UNITED STATES
NUCLEAR REGULATORY COMMISSION
WASHINGTON, D. C. 20555

SUBJECT: YANKEE ROWE REACTOR VESSEL

SAFETY ASSESSMENT OF YANKEE ROWE VESSEL

Figure 4 Shift data for $500 \pm 10^{\circ}F$ irradiations versus fluence and preliminary recommended trend curve.

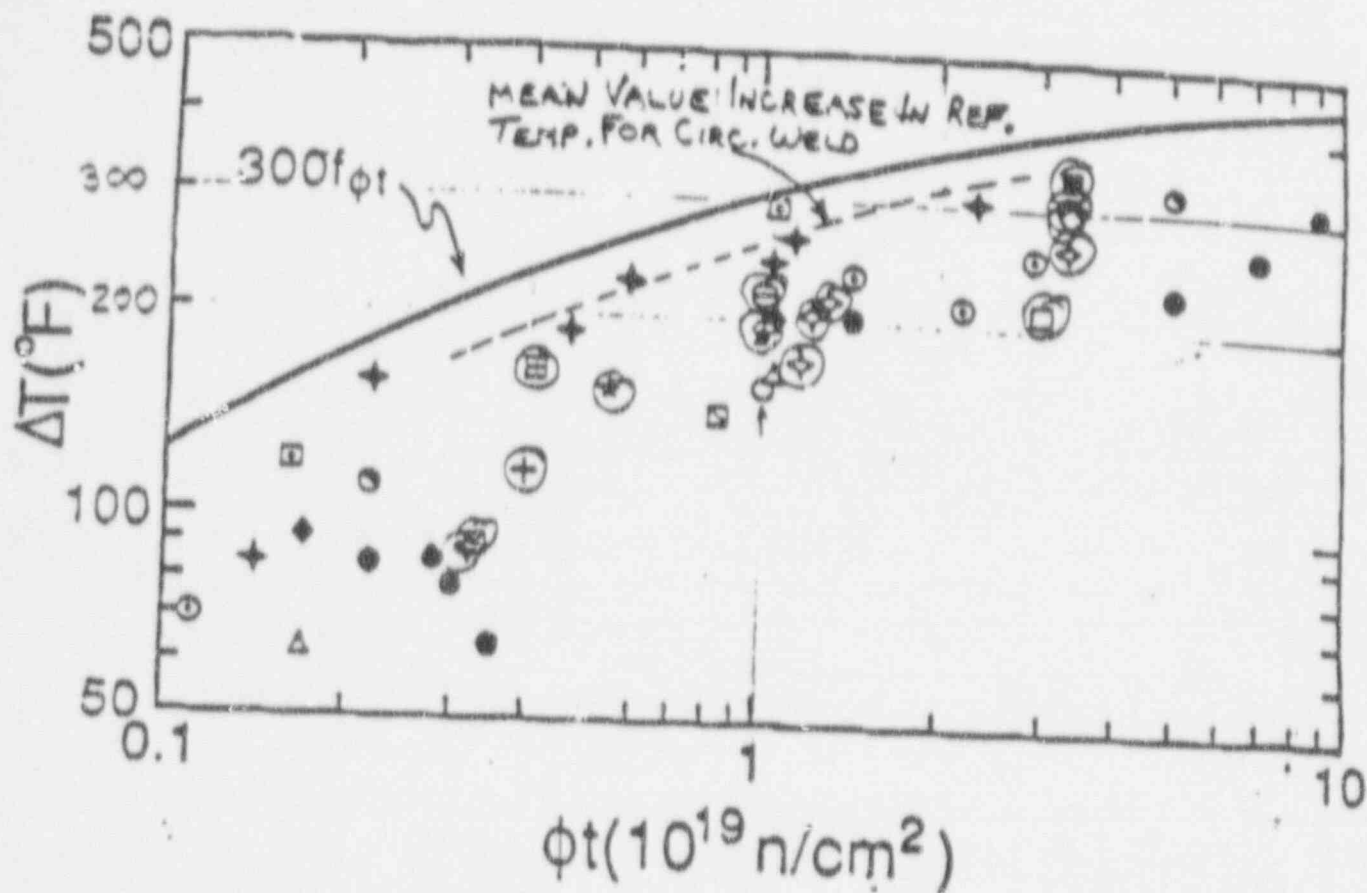
The staff estimates that an increase in nickel from .18 percent to .63 percent at 500°F irradiation temperature results in an 80°F increase in the reference temperature. This value is based on analysis by Odette (Ref. 4). The staff

Figure 1

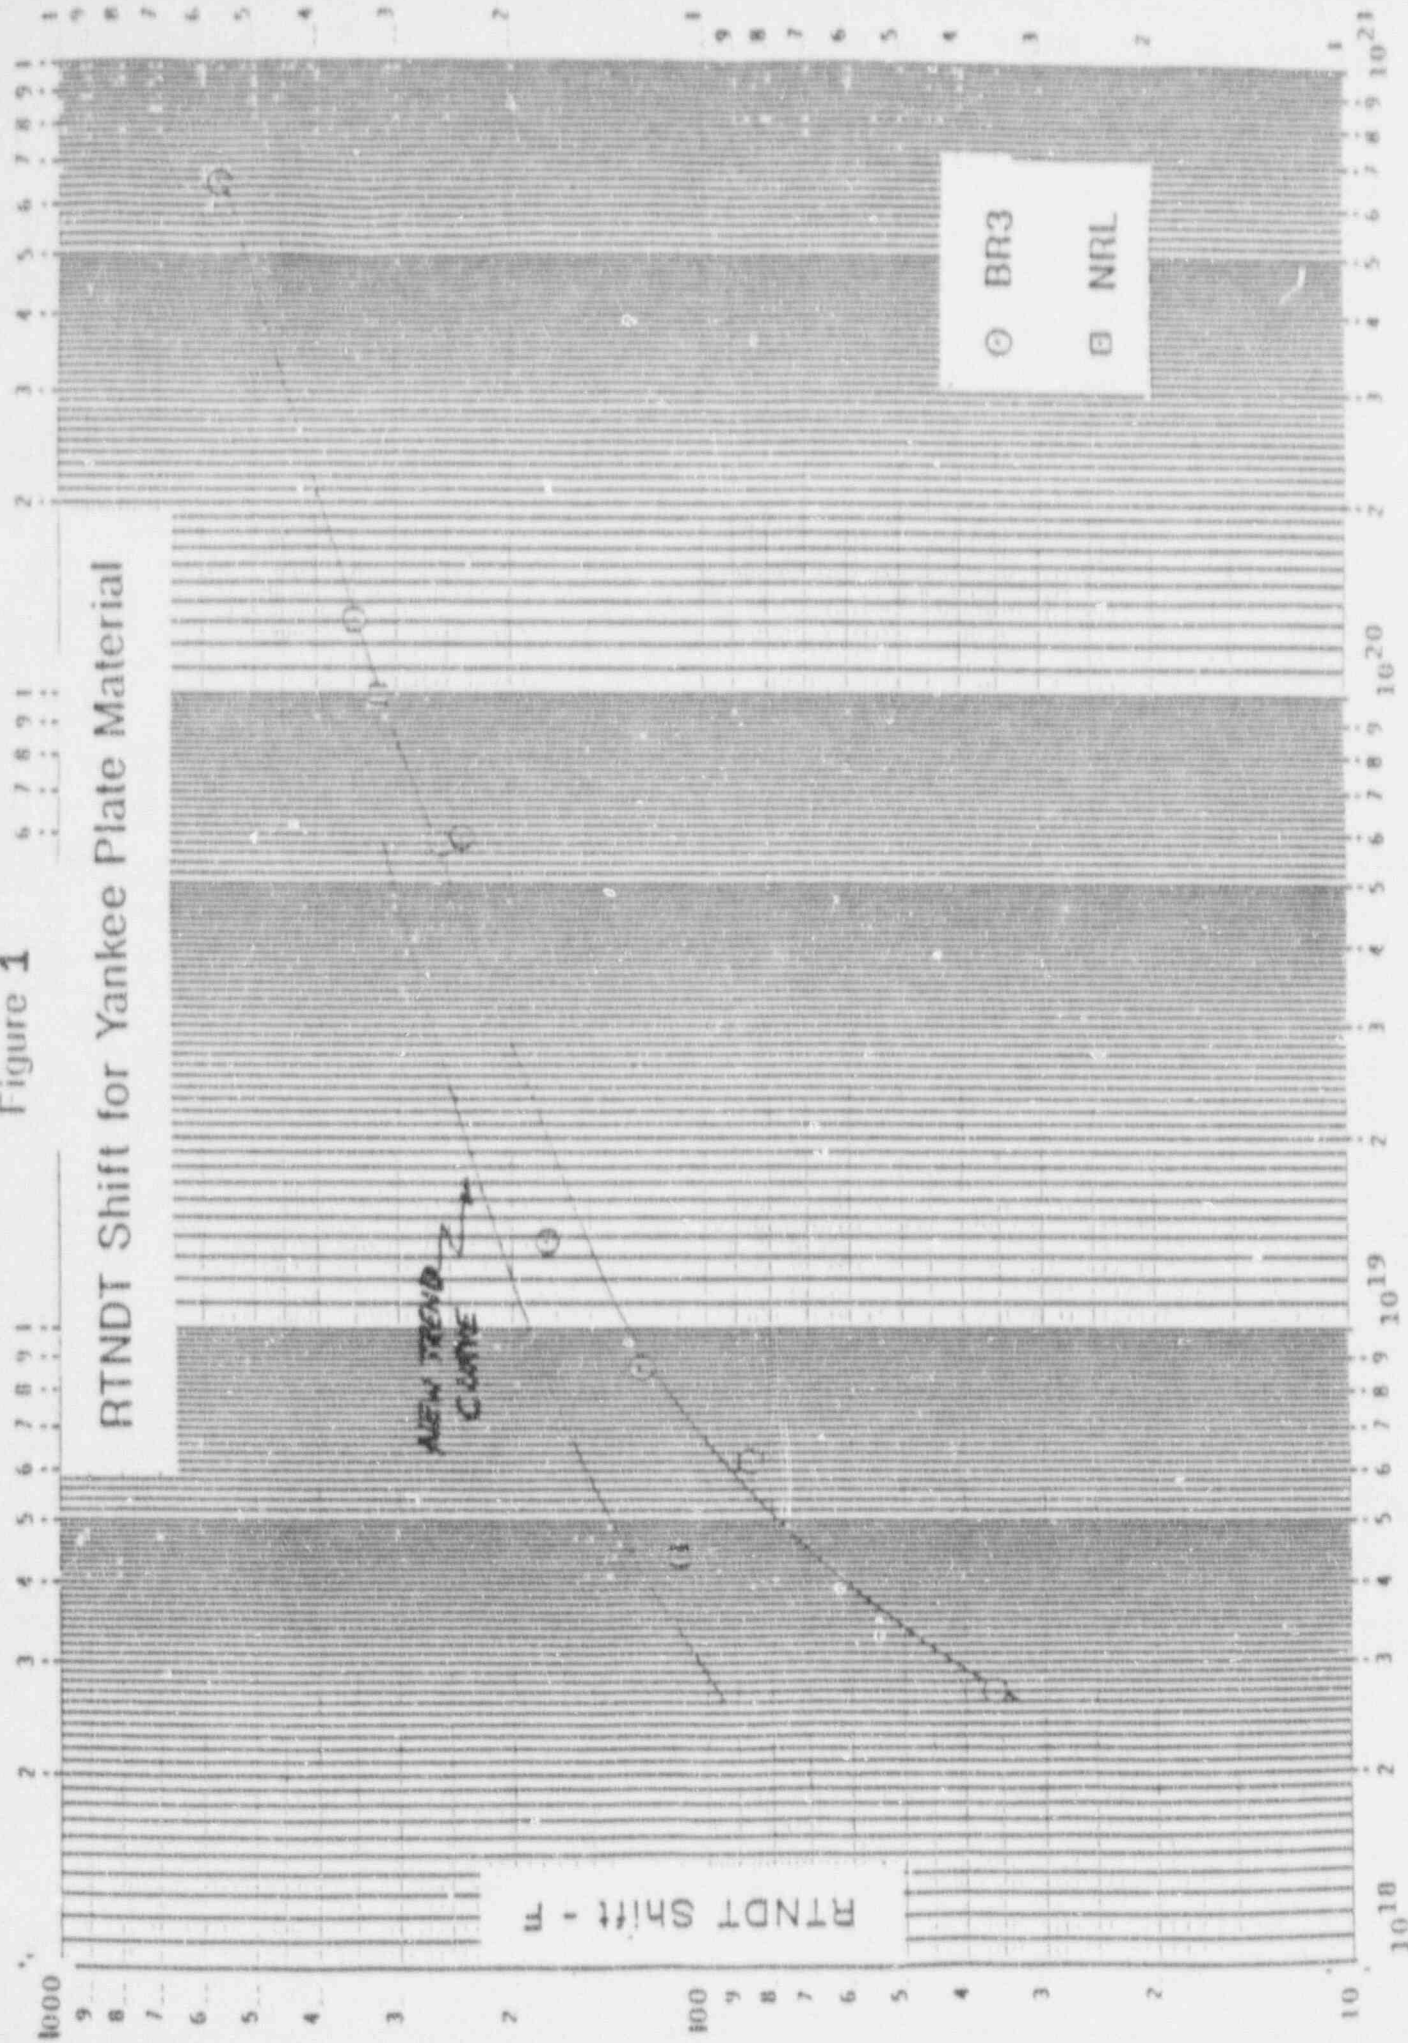
In the NRC Safety Assessment, the NRC estimated that the increased nickel content in the lower plate would contribute an additional 80°F above the revised trend curve, Figure 1, for the upper plate. Application of the new fluence distribution for the lower plate from Table 1, use of the revised trend curve, and addition of 80°F results in the reference temperature distribution for the lower plate as shown in Table 2.
